RICE LIBRARY BUILDING COMMITTEE

Project Name: Rice Public Library Renovations & Addition
 Project #: 20 18 25
 Date: **Last revised on May 20, 2020**

**VE DRAWING PACKAGE
PROGRESS SET
Date of Issue : 5.27.2020**

RE: Rice Public Library Renovations & Additions, 8 Wentworth Street, Kittery, Maine
Revised Schematic Design Estimate with Accepted VE

RICE LIBRARY
LANDSCAPE PLAN - BASIC
2020-2-3

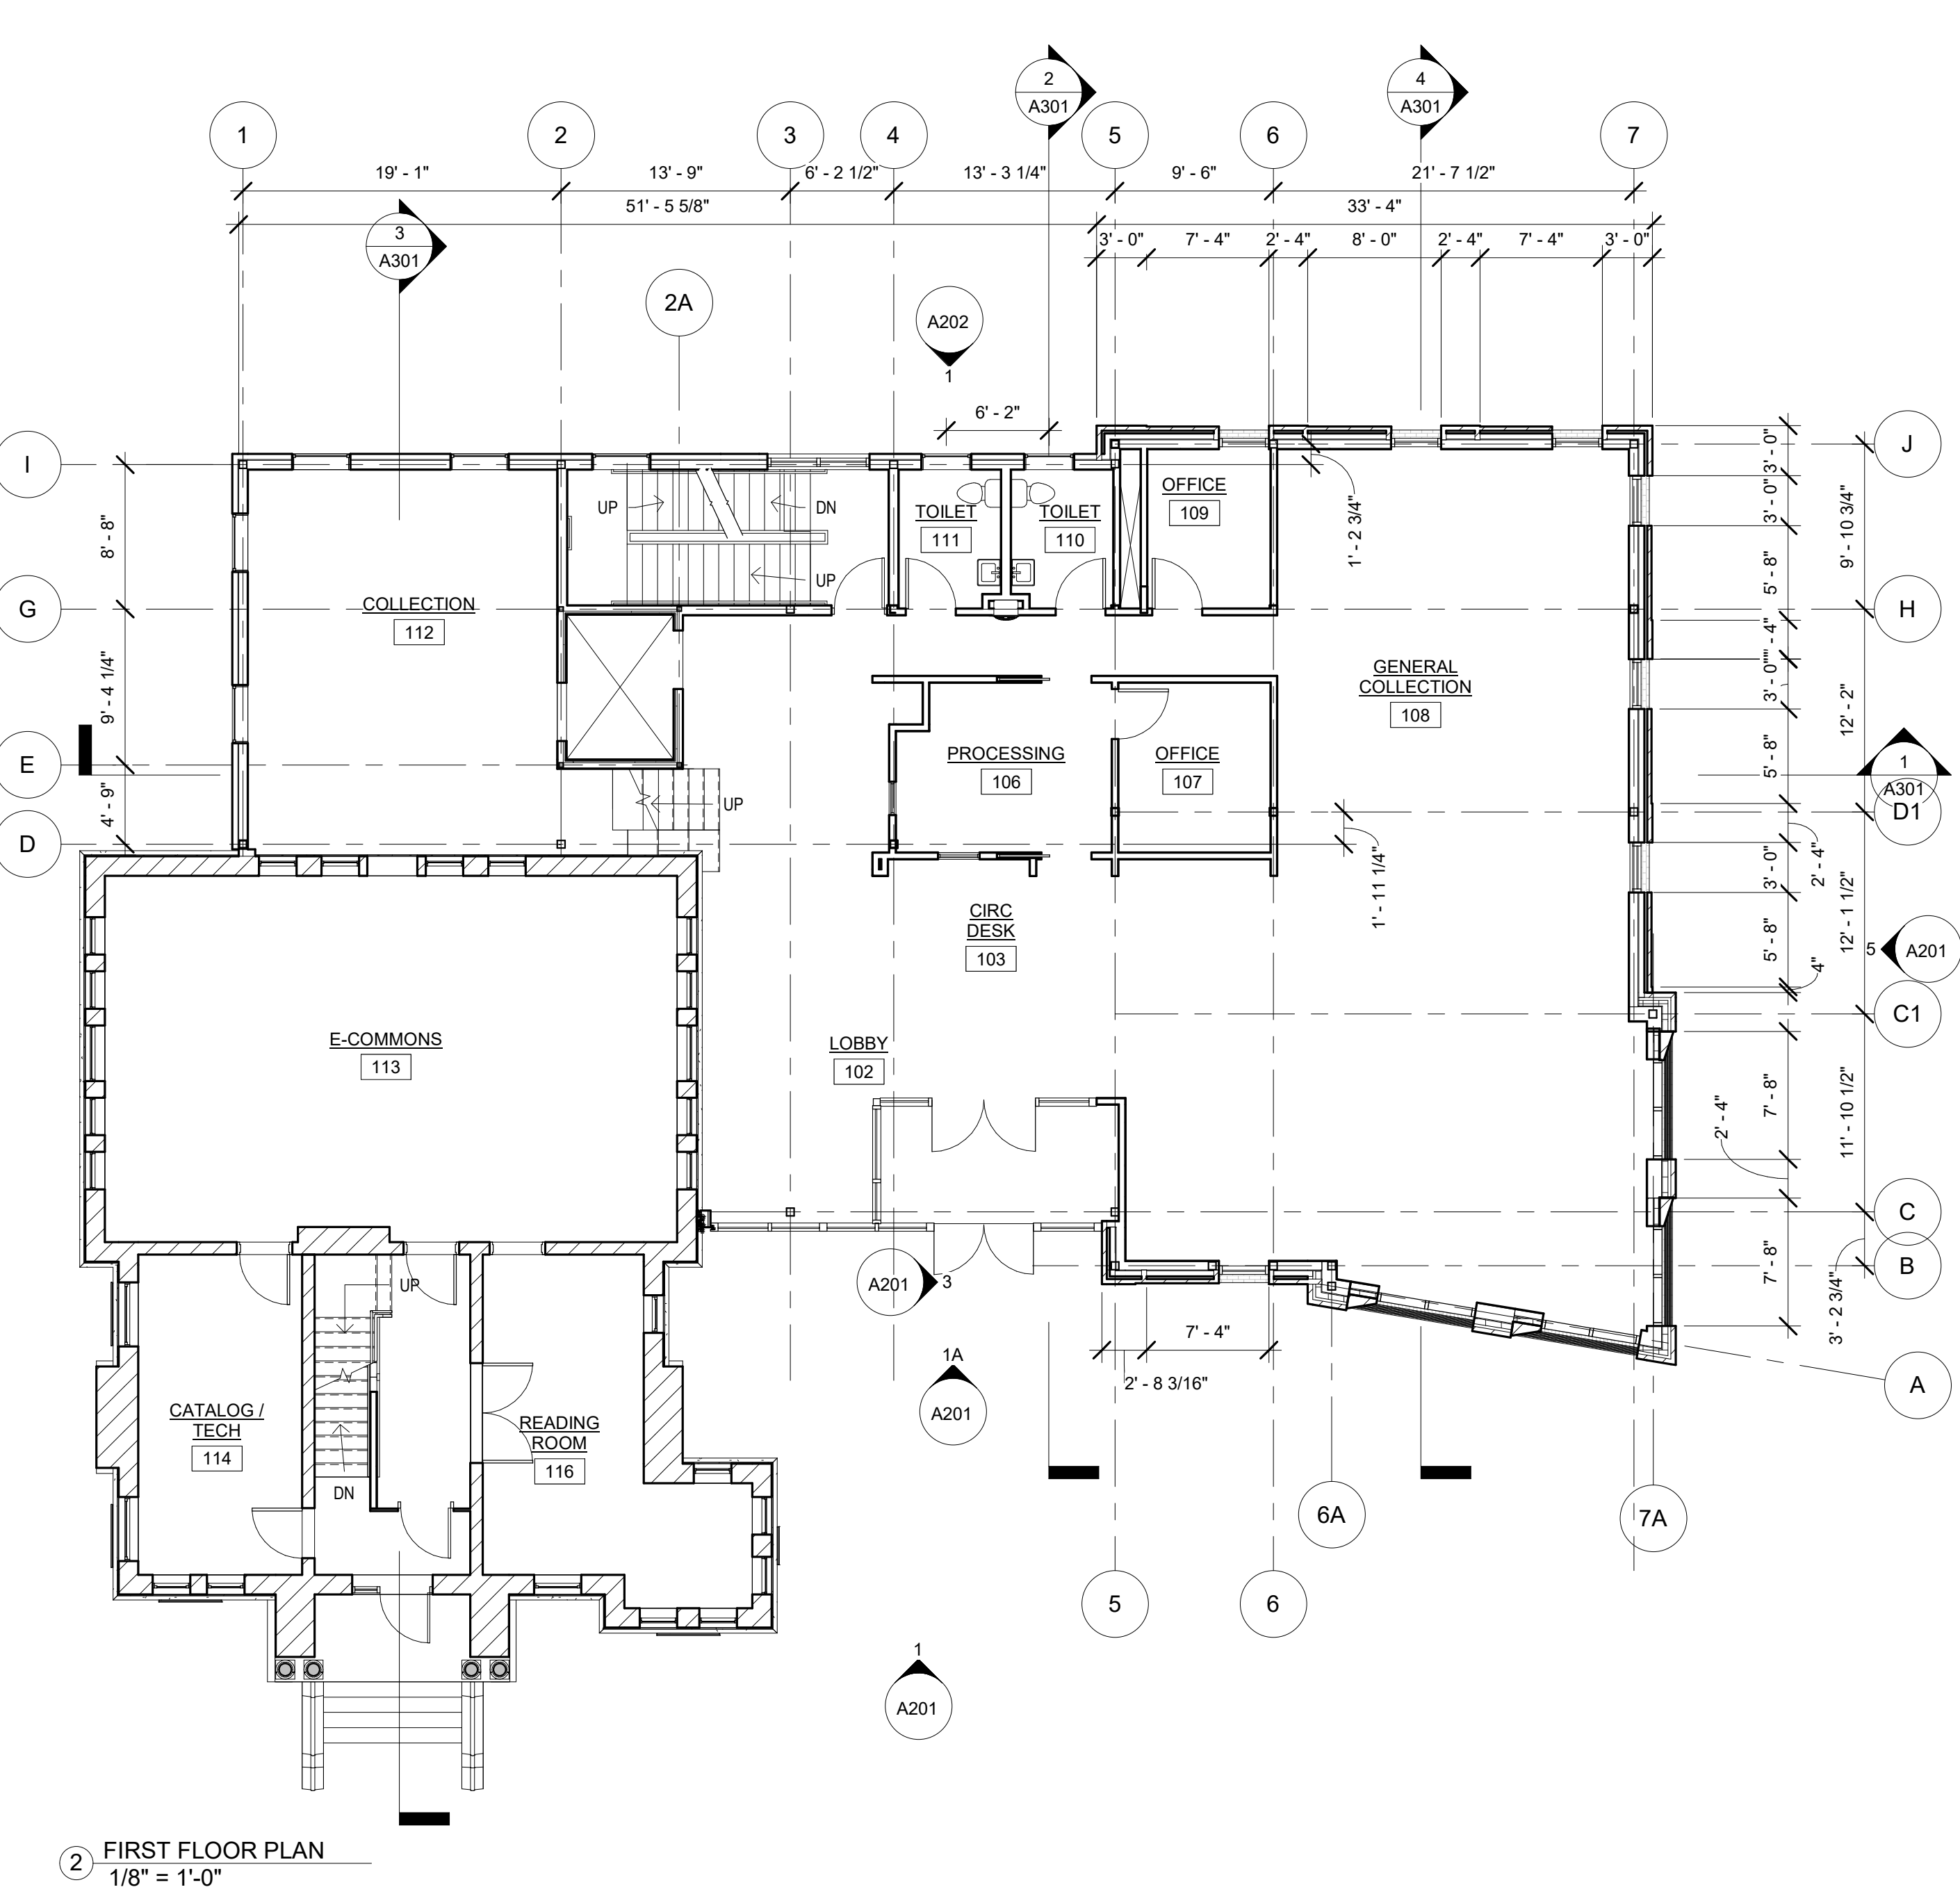
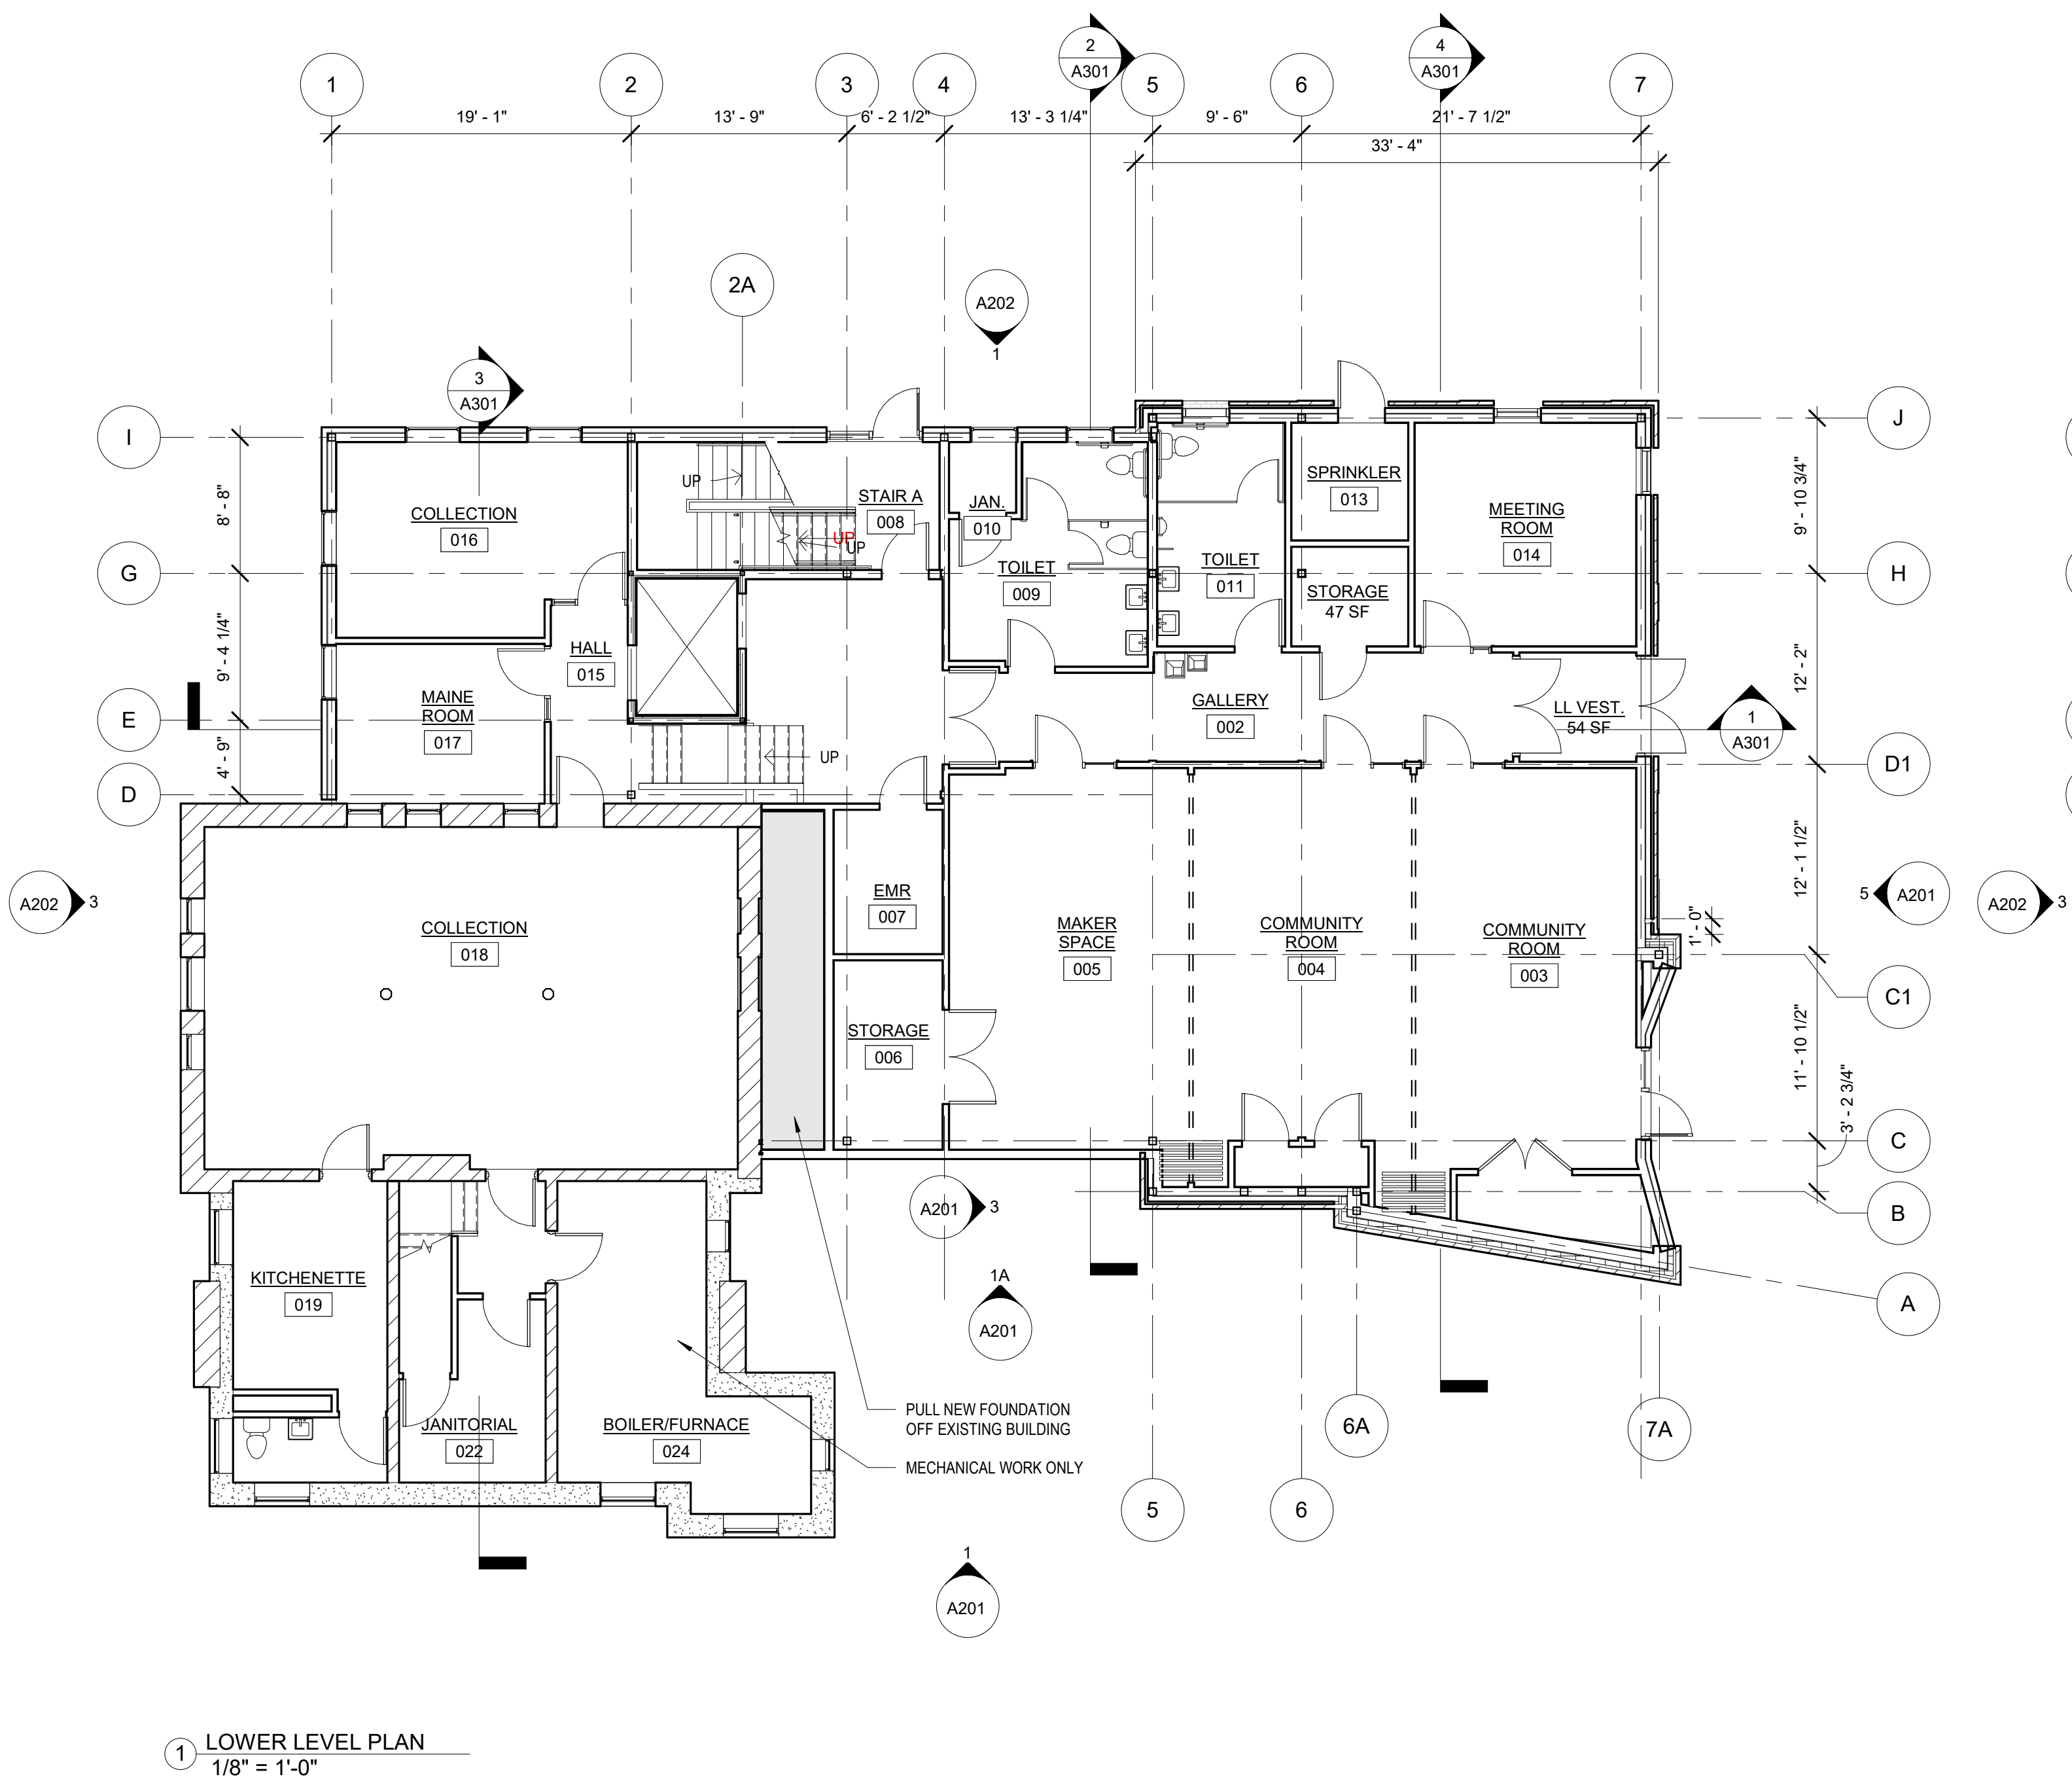
Exclude new work
in this area

Note exclusion
of retaining wall

Provide deduct
pricing for steps
and seating area
